Staff Report

Infill Housing Design Review Committee

File Number: 12-F-23-IH

Location: 1215 Dakota Ave. Parcel ID 85 | A 021

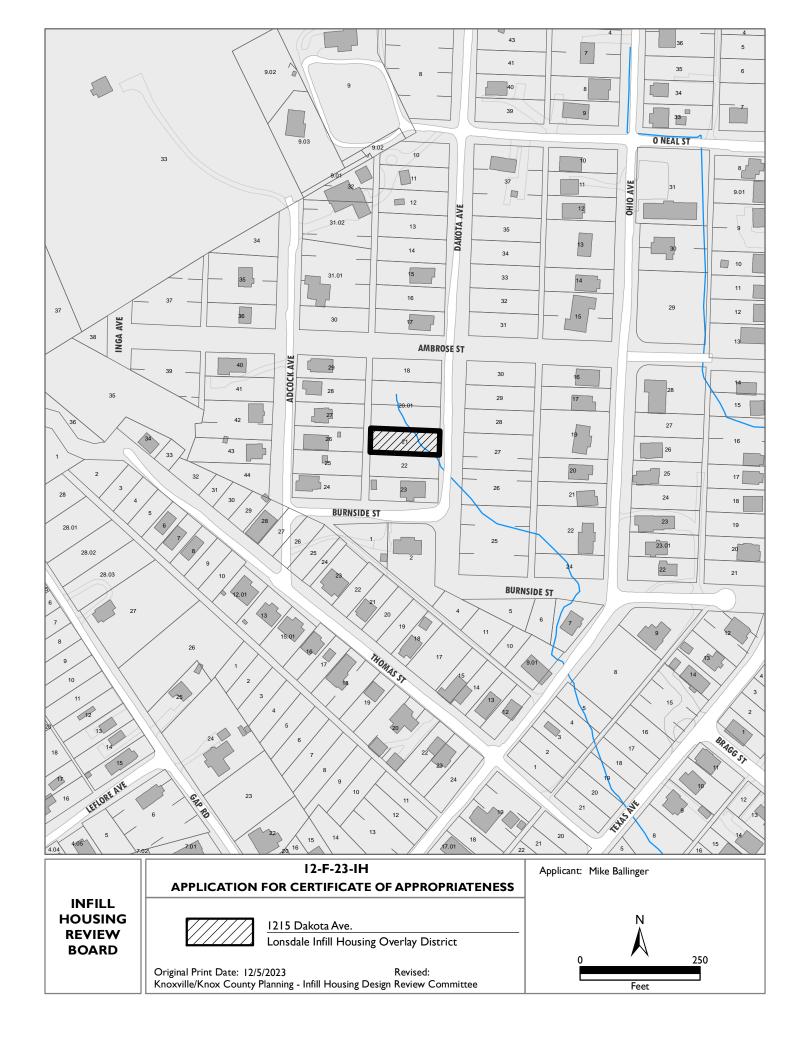
- 1. The house is proposed to be set 37.4' from the front property line. The proposed house will be accompanied by three additional new construction houses on the block, creating a new streetscape pattern on a block with no additional houses. The houses should be moved closer to the front property line to meet the base zoning's 20' front setback requirement.
- 2. The block to receive new construction is relatively vacant and lacks context. The proposed one-story, three-bay house is proportional to the dimensions of the lot and the context of the block. The side yard setbacks are consistent with the broader neighborhood.
- 3. The design guidelines and Infill Housing code discourage front yard parking. The parking should be revised to

place cars "at least 20 feet behind the front façade of the infill house, with access limited to one lane between the street and the front façade" to meet the guidelines. Final revisions may be necessary to meet City Engineering standards.

Staff recommends approval of Certificate 12-F-23-IH, subject to the following conditions: 1) front setback to be revised, moving house closer to the front property line; 2) final site plan to meet City Engineering standards; 3) parking to be revised to meet Infill Housing guidelines; 4) revisions to side elevation window placement and proportion; and 5) revisions to differentiate from adjacent new houses proposed on Dakota Avenue, with approval by staff.

Front elevation

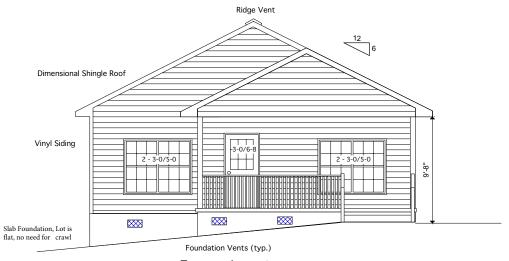
- 4. The one-story, three-bay façade is similar to the broader neighborhood context. The house is proposed for a concrete slab foundation; guidelines recommend that "new houses be about the same height as the original houses in the neighborhood." The foundation height should be elevated to at least 12" to meet guidelines.

- 5. The house features a partial-width front porch (depth not provided). The overall porch design meets the Infill Housing guidelines, though the applicant should provide measurements on porch supports and porch depth. The porch should be supported by posts that are at least 6 by 6 and measure at least 8' in depth.

- 7. The proposed roof pitch, 6/12, is the minimum typically approved in the Infill Housing overlay and meets the design guidelines.
- 8. While vinyl siding meets the Infill Housing guidelines, the final siding material should feature an overlap instead of flush panel or Dutch lap vinyl siding.

Right elevation

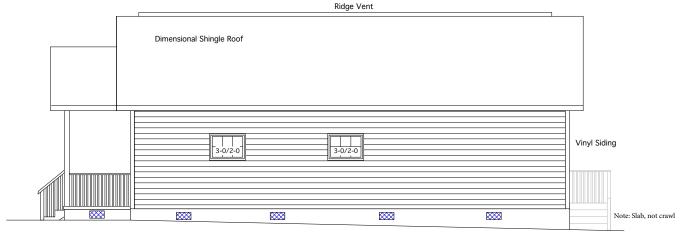
- 6. Guidelines recommend window and door styles be similar, with similar proportions and ratio of solid to void to, to historic houses on the block. Revisions should be made to the side elevations to incorporate additional transparency.
